**RESIDENTIAL DEVELOPMENT AT COOKSTOWN ROAD, ENNISKERRY,
CO. WICKLOW**

DOCUMENT TITLE: ROADS ENGINEERING, TRAFFIC & TRANSPORT ASSESSMENT

DOCUMENT NO: 18.243 – TTA – 01

APPENDIX 7 - STAGE 1 ROAD SAFETY AUDIT REPORT

Figure 4.2: Long straight street may encourage speeding

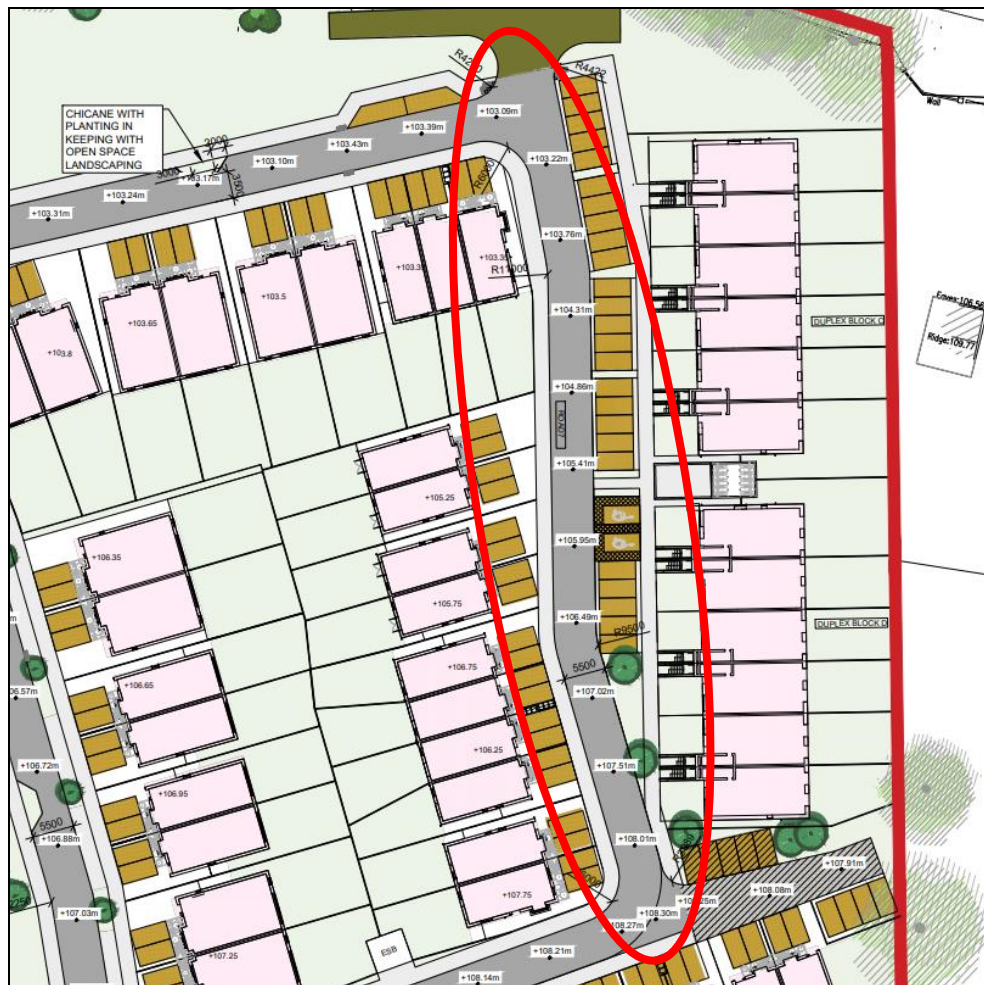
The proposed long straight street to the far eastern side of the site may encourage speeding. This may lead to collisions, such as loss-of-control type collisions, which may include vulnerable road users such as cyclists and pedestrians, including mobility and visually impaired users, being struck by traffic. This street is highlighted in Figure 4.2. Further to Item 4.14 above, a steep gradient along this street at the higher acceptable end may compound this problem.

Provide traffic calming measures to control speeding.

Figure 4.3: Proposed footpath terminating abruptly at Cookstown Road with no continuity of pedestrian provision

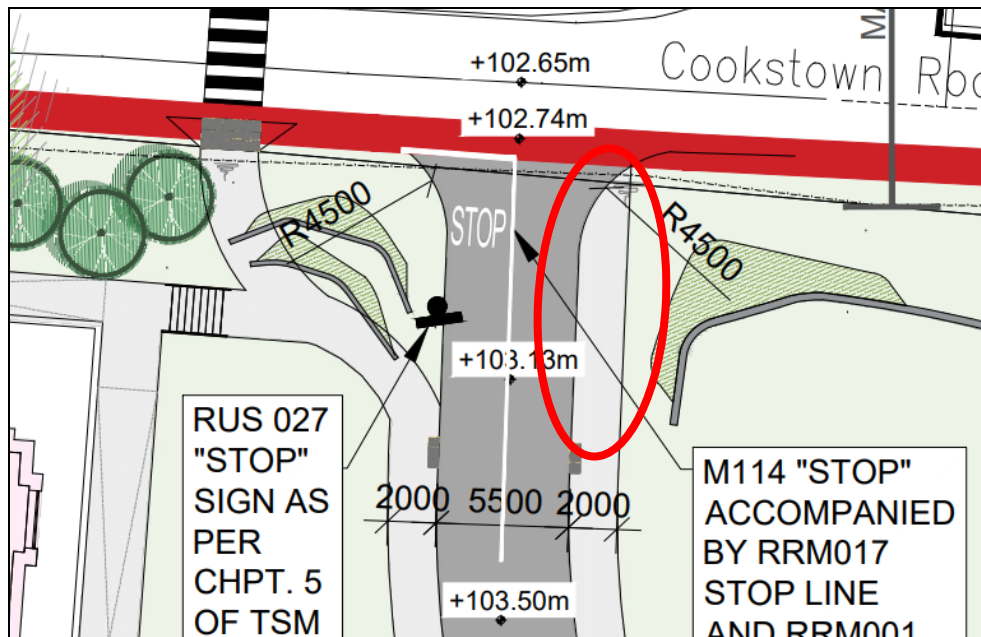
The drawings provided for audit show the proposed footpath to the eastern side of the main development access road terminating abruptly at Cookstown Road without any indication as to how pedestrians are to continue their journey beyond this point. This footpath is highlighted in Figure 4.3. This may lead to confusion and result in non-motorised users entering the carriageway at inappropriate locations. This may result in collisions between non-motorised users and traffic.

Figure 4.4: Pedestrian crossings linking directly to landscaped areas

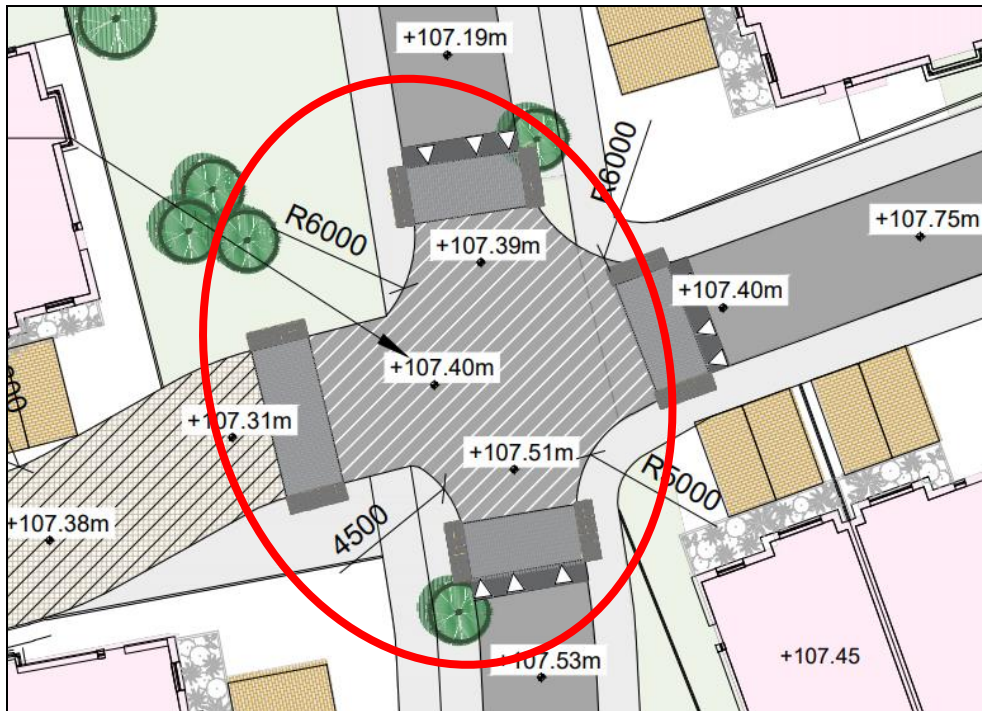
The drawings provided for audit show pedestrian crossings, including at the junction shown in Figure 4.4, linking directly to landscaped areas and having no continuation of footpath facilities. Without appropriate facilities pedestrians may enter the carriageway at inappropriate locations and be struck by traffic or may slip or trip in areas not intended for pedestrians.

Figure 4.5: Car parking spaces to front of Duplex Block C with no pedestrian footway in between

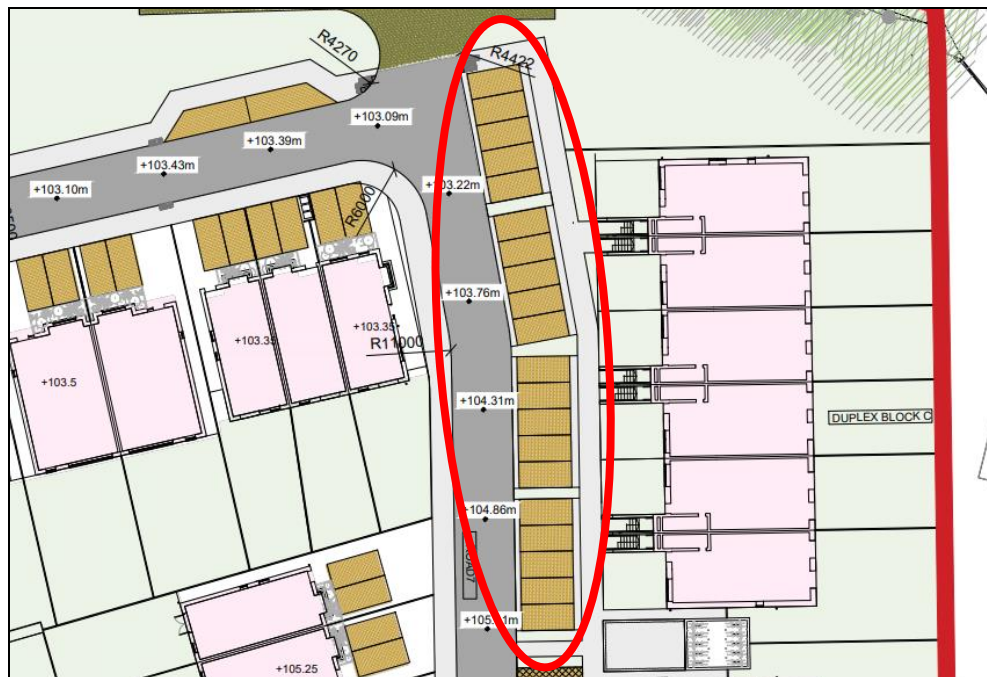
The drawings provided for audit appear to show 20 no. car parking spaces to the front of Duplex Block C at the northeast corner of the site with no pedestrian footway in between the parking spaces. These parking spaces are highlighted in Figure 4.5. With this arrangement some non-motorised users such as wheelchair and pushchair users may need to negotiate a circuitous route, partly in the carriageway, if required to access the carriageway end of the parking bays. This may encourage the use of landscaped areas to gain access which may lead to trips and falls.

Ensure that appropriate facilities are provided along pedestrians' desired routes. This could include, for example, a footway located midway between the car parking spaces to the front of Duplex Block C to provide a more direct pedestrian route between the main footpath to the front of Duplex Block C and the carriageway end of the car parking spaces.

Figure 4.6: Unclear if relevant vehicles can perform turnabout manoeuvres along cul de sac street

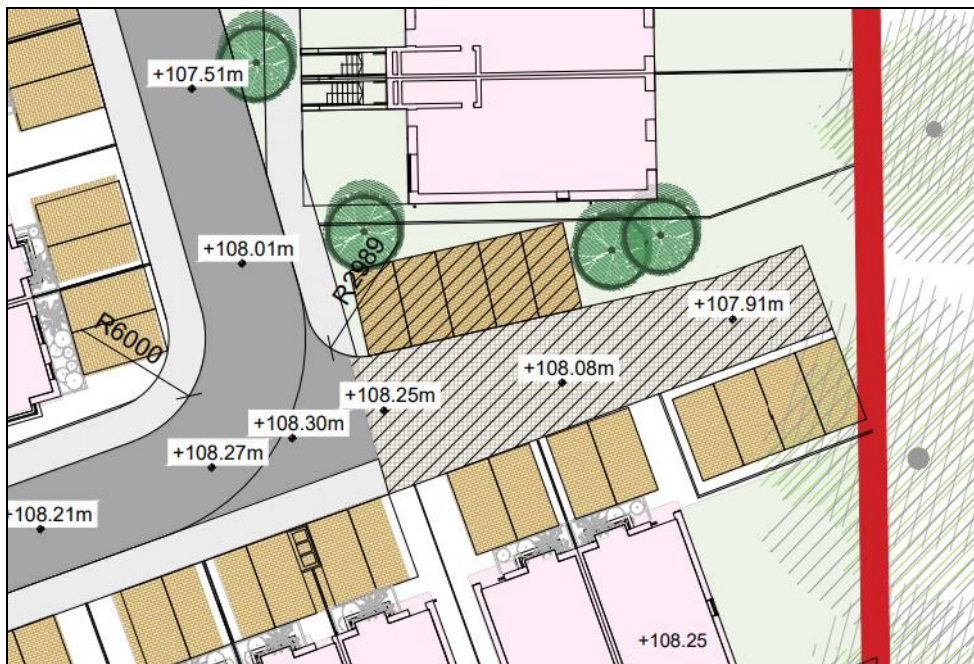
The drawings provided for audit show a cul de sac street at the eastern side of the site. It is unclear from the information provided if the relevant vehicles could perform turnabout manoeuvres along this cul de sac street within the confines of the carriageway, particularly if all car parking spaces are occupied. Vehicles reversing out of the cul de sac street and onto the adjoining street may lead to collisions with other road users. Figure 4.6 refers.

Figure 4.3: Pedestrian crossings linking directly to landscaped areas

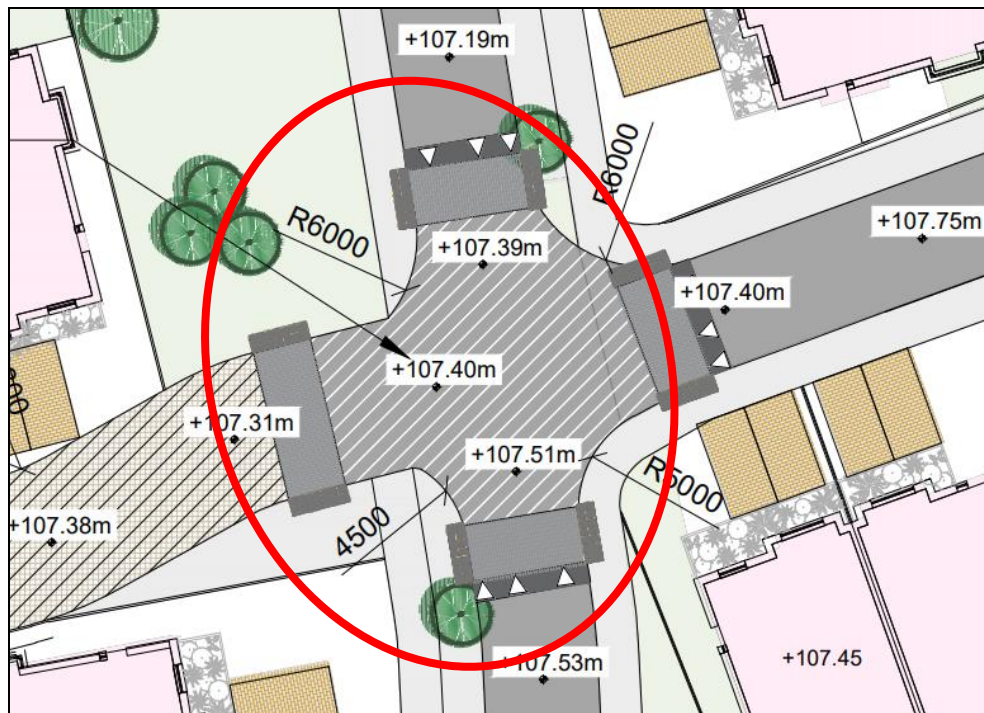
The drawings provided for audit show pedestrian crossings, including at the junction shown in Figure 4.3, linking directly to landscaped areas and having no continuation of footpath facilities. Without appropriately accessible facilities pedestrians may enter the carriageway at inappropriate locations and be struck by traffic or may slip or trip in areas not intended for pedestrians.

Figure 4.4: Car parking spaces to front of Duplex Block C with no pedestrian footway in between

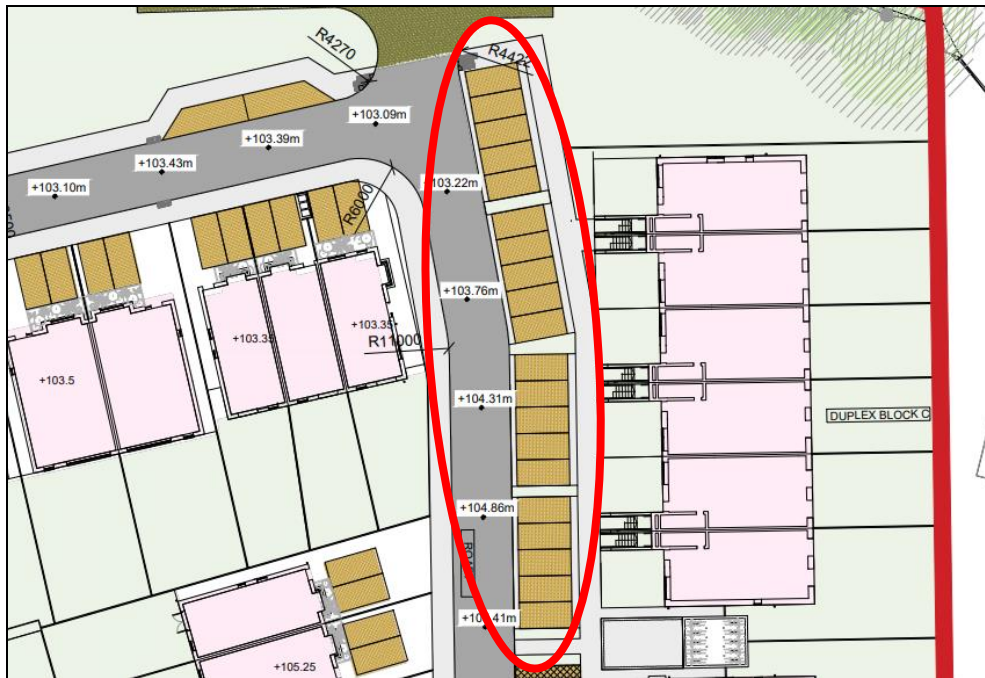
The drawings provided for audit appear to show 20 no. car parking spaces to the front of Duplex Block C at the northeast corner of the site with no pedestrian footway in between the parking spaces. These parking spaces are highlighted in Figure 4.4. With this arrangement some non-motorised users such as wheelchair and pushchair users may need to negotiate a circuitous route, partly in the carriageway, if required to access the carriageway end of the parking bays. This may encourage the use of landscaped areas to gain access which may lead to trips and falls.

Ensure that appropriate facilities are provided along pedestrians' desired routes. This could include, for example, a footway located midway between the car parking spaces to the front of Duplex Block C to provide a more direct pedestrian route between the main footpath to the front of Duplex Block C and the carriageway end of the car parking spaces.

Figure 4.5: Long straight street may encourage speeding

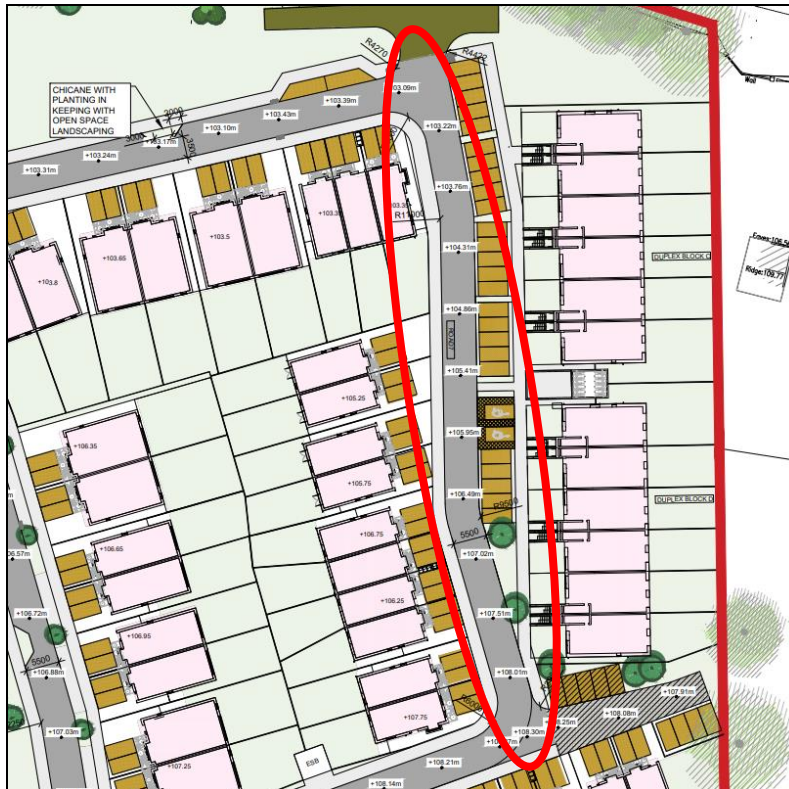
The proposed long straight street to the far eastern side of the site may encourage speeding, which for pedestrian users, is a safety concern and may result in collisions, including pedestrians being struck by traffic, and may restrict the accessibility, desirability and comfort of the street. This street is highlighted in Figure 4.5. Further to Item 4.1.3 above, a steep gradient along this street at the higher acceptable end may compound this problem.

Provide traffic calming measures to control speeding.
